# CONFERENCE MEMORANDUM 10-2-2014

Project: Green Acres Housing Development

**Project No.:** 13498

Project Phase: SD Phase

SITE OPTIONS & STUDIES

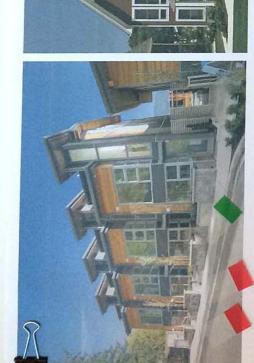
Like, but depends on final design -No driveway is impacted

- -Looks most appealing

-Like green space & set back of housing from street & also sharing traffic load to two streets
